Report: TAB Report
Function: Test, Adjust, & Balance
Date: 09/23/2025
Completed By: National TAB

06-09-25 WAWA #6305 WAYCROSS, GA

Project: 06-09-25 WAWA #6305 WAYCROSS, GA

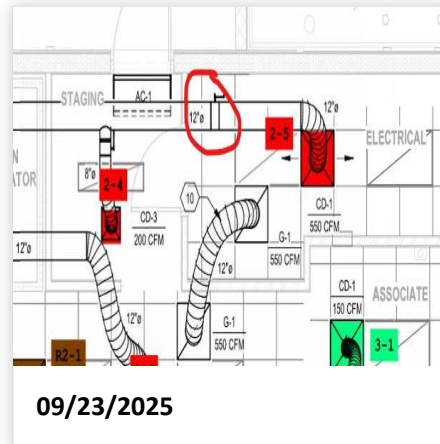
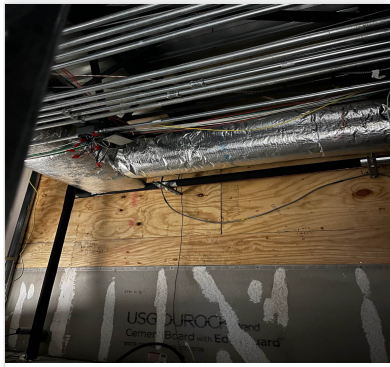
Issue Name : 1. UPDATED 9/22: Branch damper for diffuser 2-4 and 2-5 is broken
Description : Unable to balance both dampers with design air flow. Recommended to replace damper. UPDATE 9/22: Branch damper is now functional however there is no damper controlling only SGRD2-5. Total airflow for the branch has been set within design. SGRD2-4 damper is covered with mastic and draw band.
Created By : National TAB **Assigned To :** National TAB - Will Turnbough
Status : Open
Priority : Urgent **Asset Tag :**
Originated Date : 06/11/2025 - Ian Fuller - National TAB

- **06/30/2025 National TAB - Ian Fuller**
 - Issue not resolved as of 6/30. Diffusers on branch are reading same CFM readings, damper is still fully open.

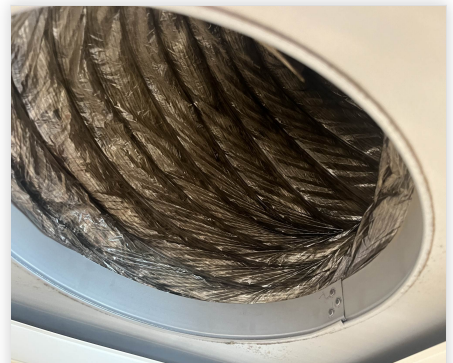
Issue Name : 3. RTU-2 return diffusers are missing dampers
Description : Return Diffuser 2-1, 2-3, and 2-4 are missing balancing dampers. Recommended to install damper in order to balance individual diffusers.
Created By : National TAB **Assigned To :** National TAB - Will Turnbough
Status : Open
Priority : Urgent **Asset Tag :**
Originated Date : 06/11/2025 - Ian Fuller - National TAB

- **09/23/2025 National TAB - Stephen Tassinaro**
 - Dampers have been installed on 4 out of the 5 returns. However they are installed in such a way that they cannot fully open. Instead they make contact with the face of the diffusers and remain restrictive and unable to be balanced.

- **06/30/2025 National TAB - Ian Fuller**
 - Issue nit resolved as of 6/30. Dampers still missing on specified diffusers.

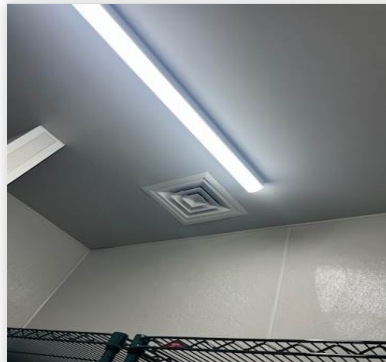
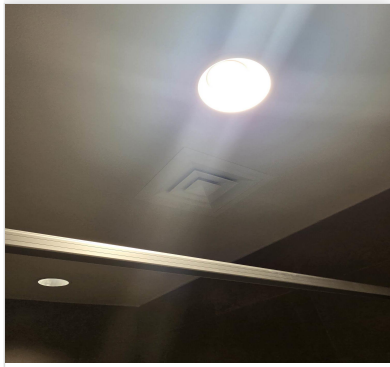
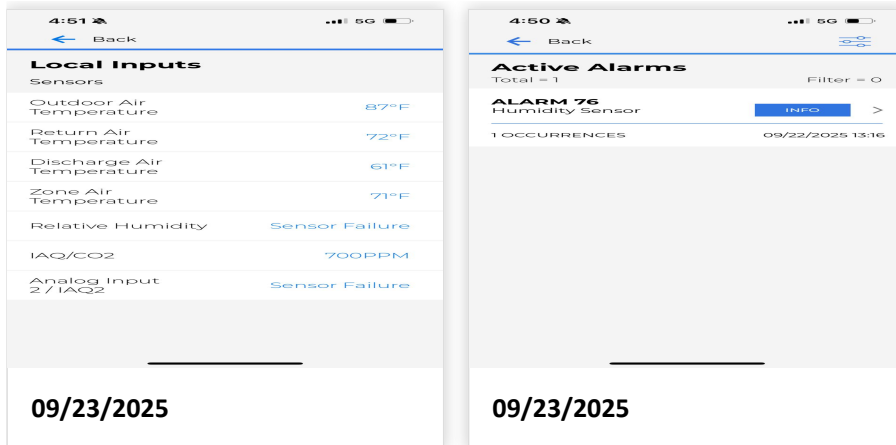
Issue Name : EF1-1and EF4-4 have wrong diffuser type installed
Description : Currently installed are CD-4 supply diffusers when GRD calls for G-3 exhaust diffusers.
Created By : National TAB **Assigned To :** National TAB - Will Turnbough
Status : Open
Priority : Urgent **Asset Tag :**
Originated Date : 06/10/2025 - Ian Fuller - National TAB

- **09/23/2025 National TAB - Stephen Tassinaro**
 - Unresolved 9/22.

- **06/30/2025 National TAB - Ian Fuller**
 - Issue not resolved as of 6/30. Supply type diffusers still installed.

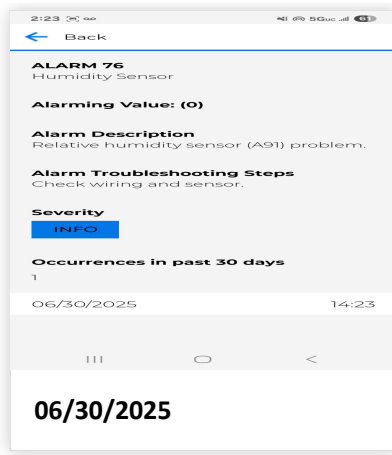
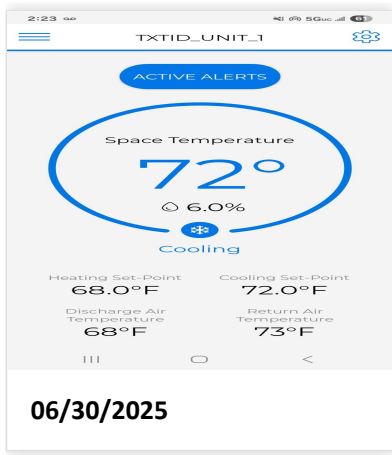
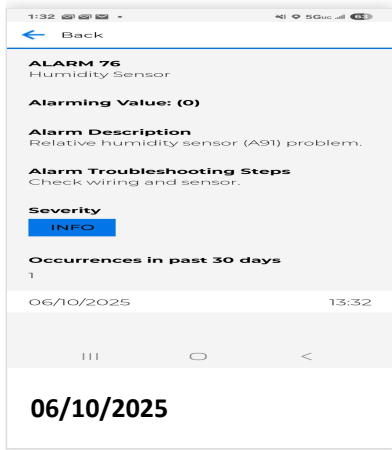
Issue Name : RTU-1 humidity sensor
Description : Humidity sensor is not reading correct humidity. Sensor starts to read at 8% then jumps to around 35% when humidity in the building is around 53 % RH. Humidity sensor wiring is per spec.
Created By : National TAB **Assigned To :** National TAB - Will Turnbough
Status : Open
Priority : High **Asset Tag :**
Originated Date : 06/10/2025 - Ian Fuller - National TAB

- **09/23/2025 National TAB - Stephen Tassinaro**
 - RTU-1 is still alarming for humidity sensor. Unresolved.

- **06/30/2025 National TAB - Ian Fuller**
 - Issue nit resolved as of 6/30. Core alarm is still present on system.

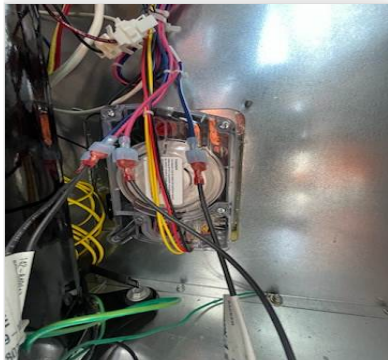
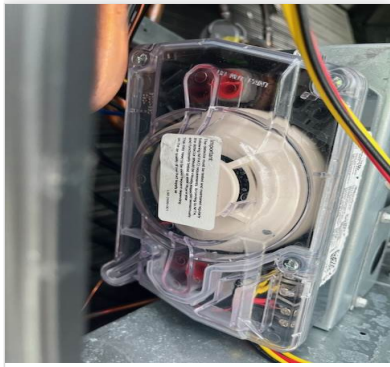
Issue Name : Smoke detector dust plugs are still in unit
Description : Recommended to remove dust plugs in all units before store operation.
Created By : National TAB **Assigned To :** National TAB - Will Turnbough
Status : Open
Priority : Medium **Asset Tag :**
Originated Date : 06/10/2025 - Ian Fuller - National TAB

- **09/23/2025 National TAB - Stephen Tassinaro**
 - Unresolved 9/22.

- **06/30/2025 National TAB - Ian Fuller**
 - Issue not resolved as of 6/30.
